Oriel
Creating the centre for
advancing eye health

DAS ADDENDUM, SECTION 73 MINOR MATERIAL AMENDMENT TO BASEMENT

Project Name	Job No.	Date of First Issue	Scale	Suitability Code	Revision	Stage
Oriel	127091	2023-05-12	A3 NTS	D5 - Suitable for Planning Application	P03	RIBA 4
Document Number	Document Title					
ORL-IBI-XX-XX-TRP-A-405104	DAS Addendum, Section 73 Minor Material Amendment to Basement

Proposed Basement Level showing the fire fighting and escape stairs and core stairs

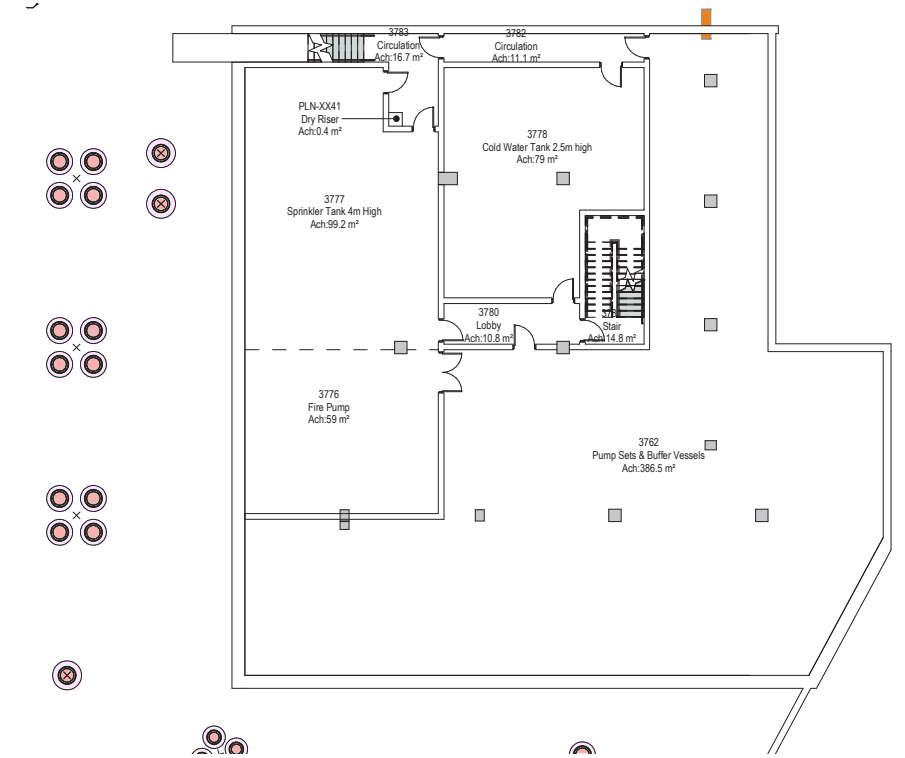
The proposed basement level for the Oriel project is 2.05 meters deeper into the ground than the previous floor level, bringing the new depth to 15.1m.

It is important to note that this basement level is designated for MEP services only, which means that it will not be accessible to the public.

An additional stair from the lower ground floor, which will provide easy access and escape to the MEP services area. Another dedicated fire fighting and escape stairs have also been added that is directly accessed from Granary Street by the loading bay on the upper ground floor. This is required in the event of an emergency.

The Proposed Northwest Elevation with the fire fighting and escape door added. These changes to the Northwest elevations are minimal

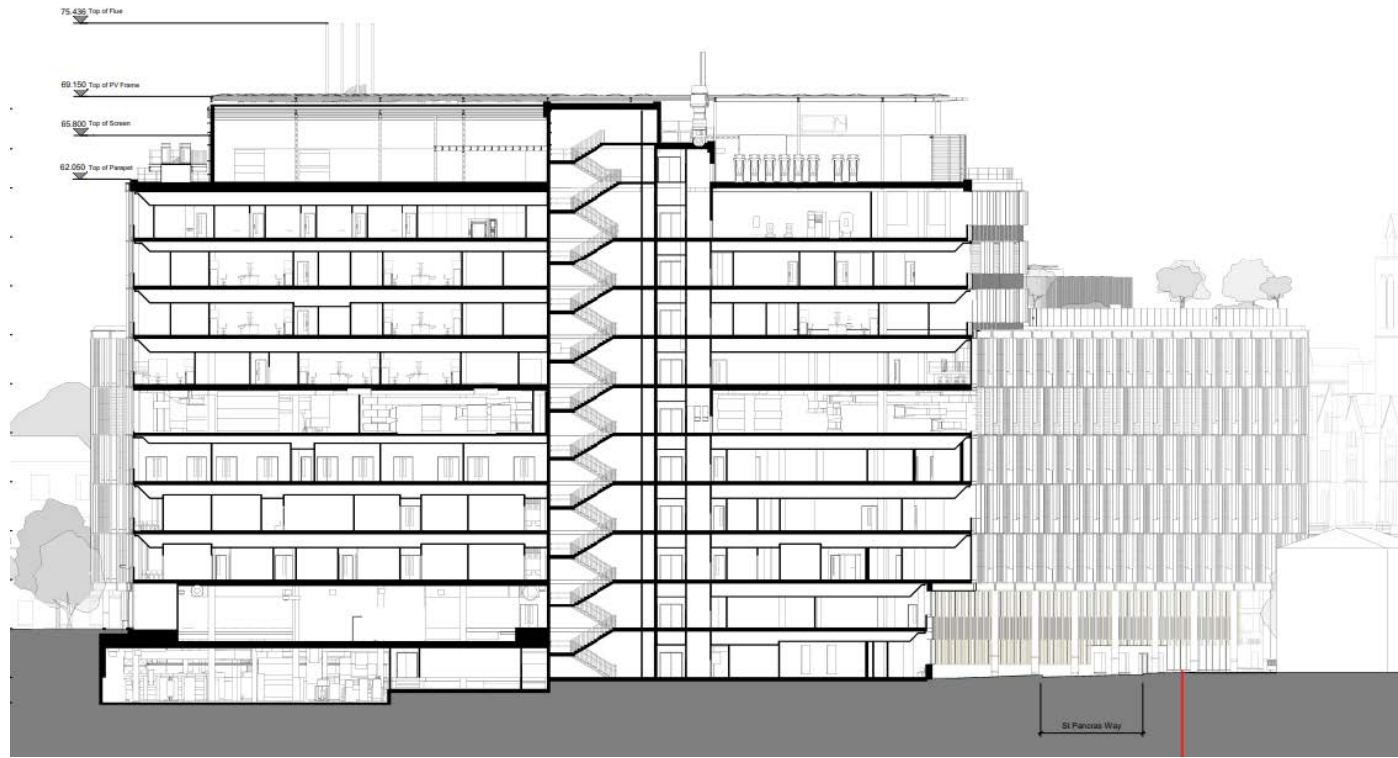
The previous submission of the Northwest Elevation

Section BB - Previous Submission

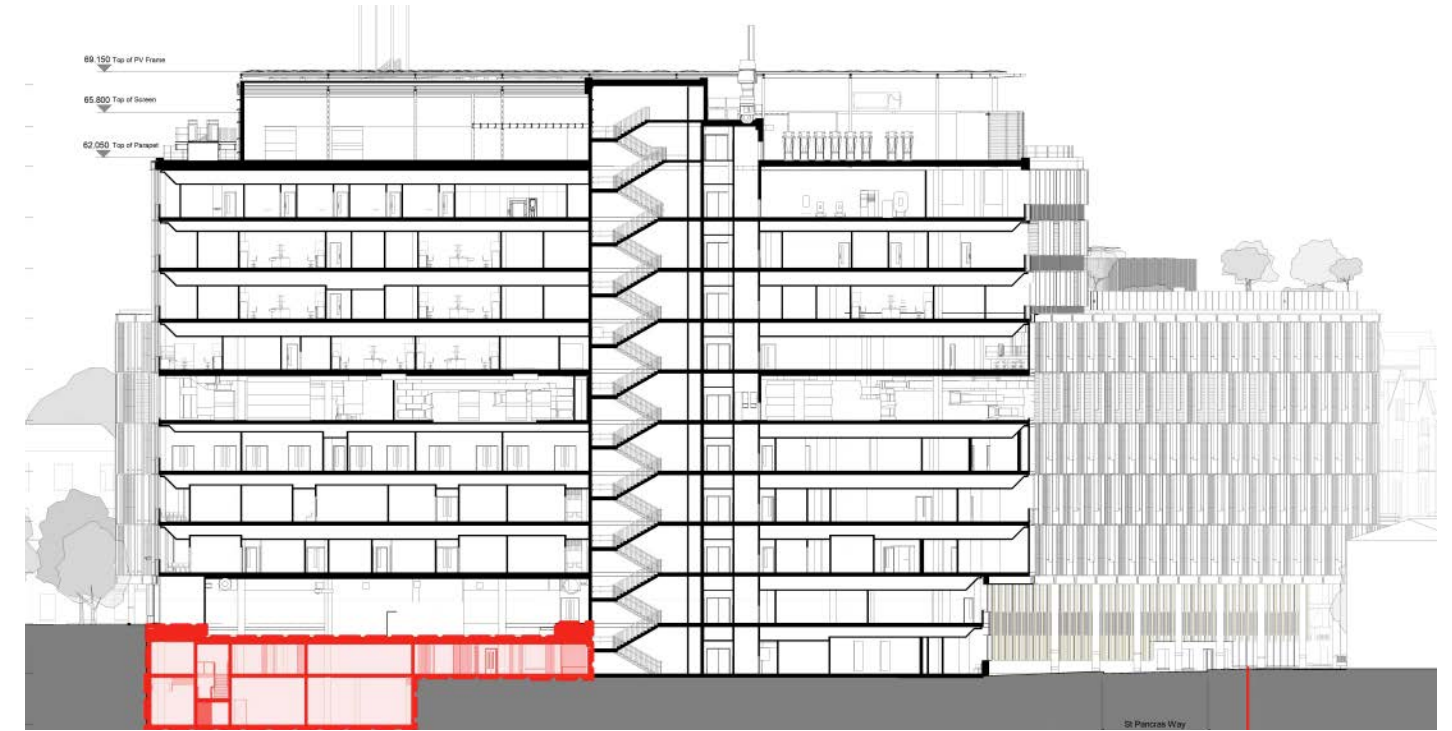
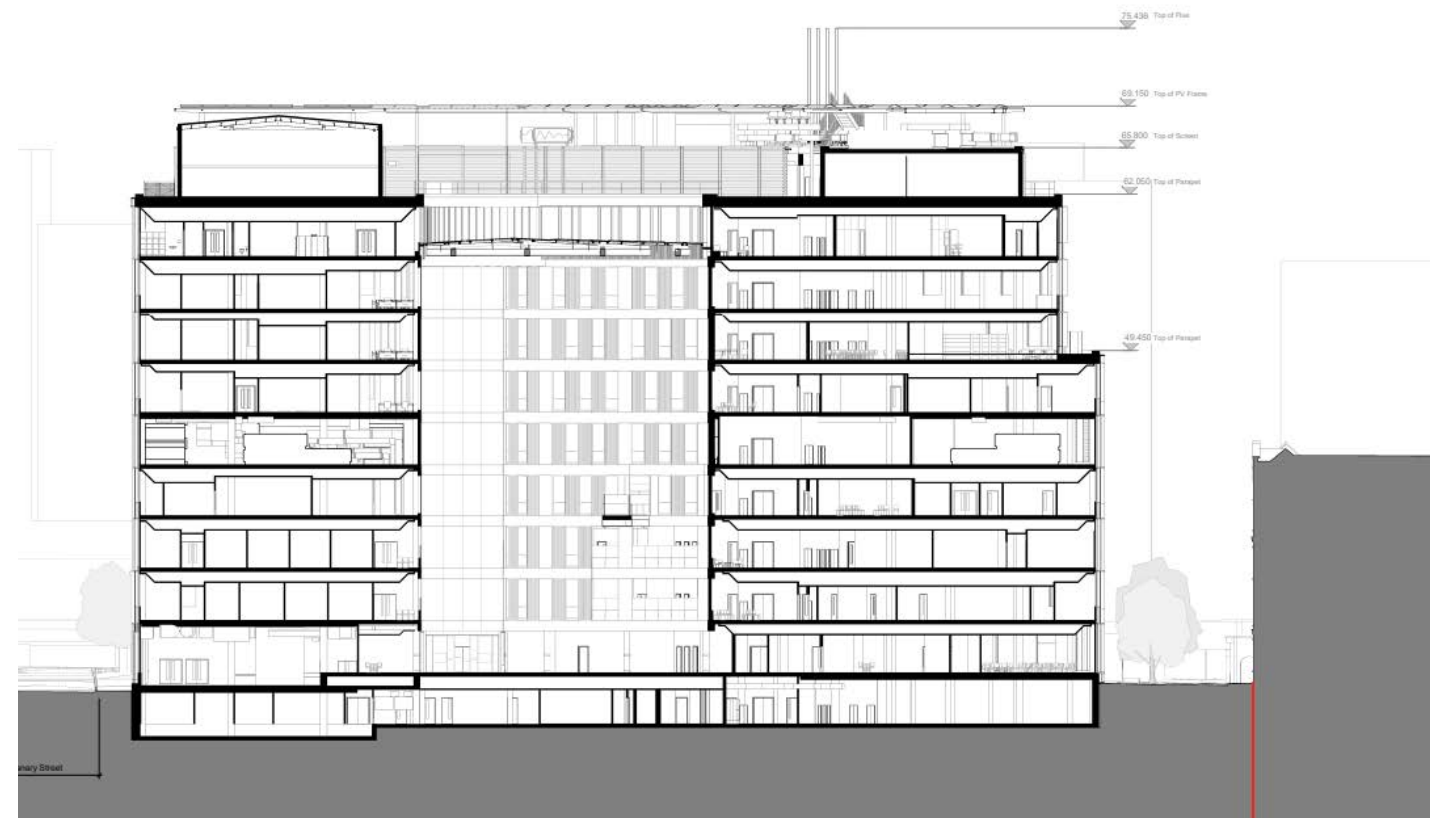
Section BB - Proposed Submission

Section CC - Previous Submission

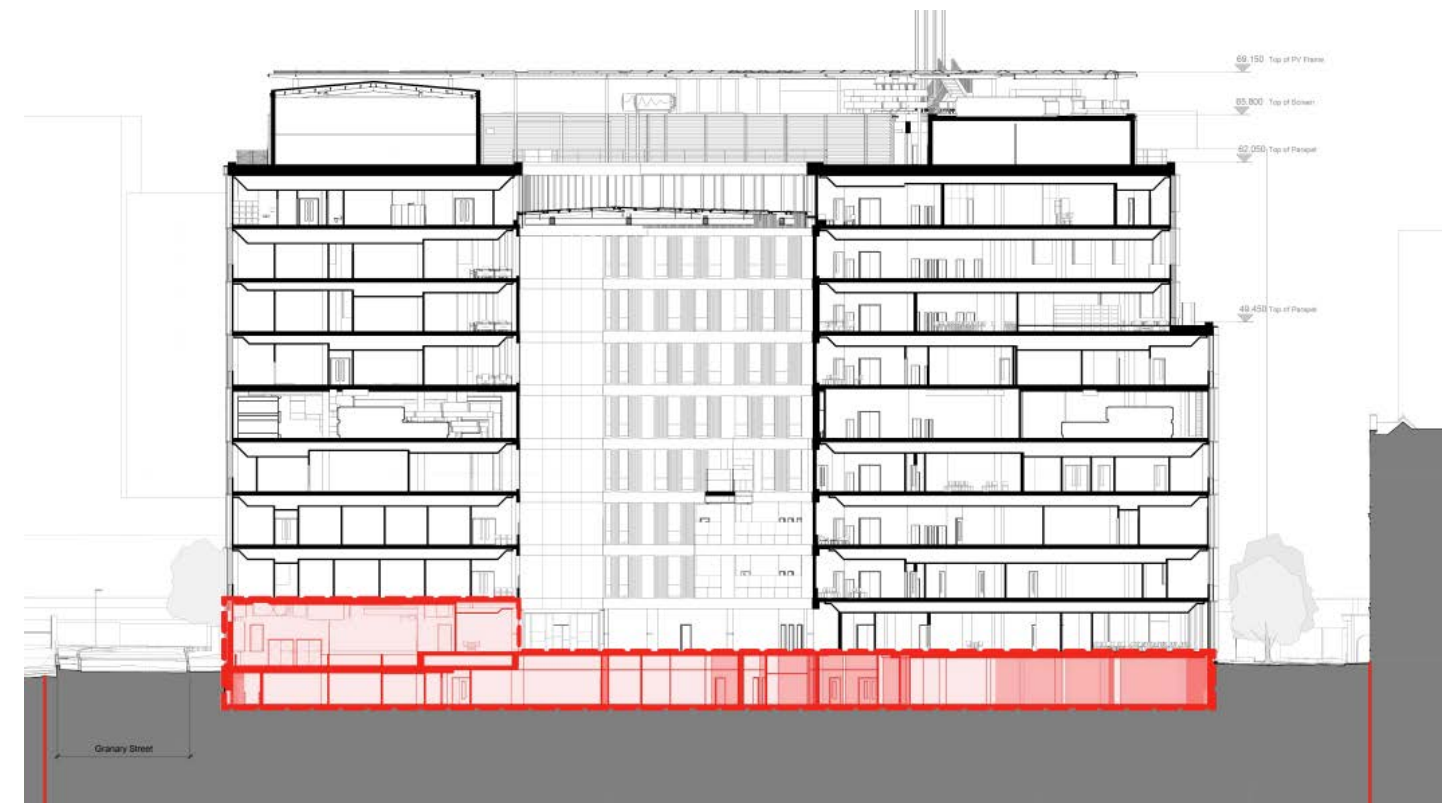
Section CC - Proposed Submission
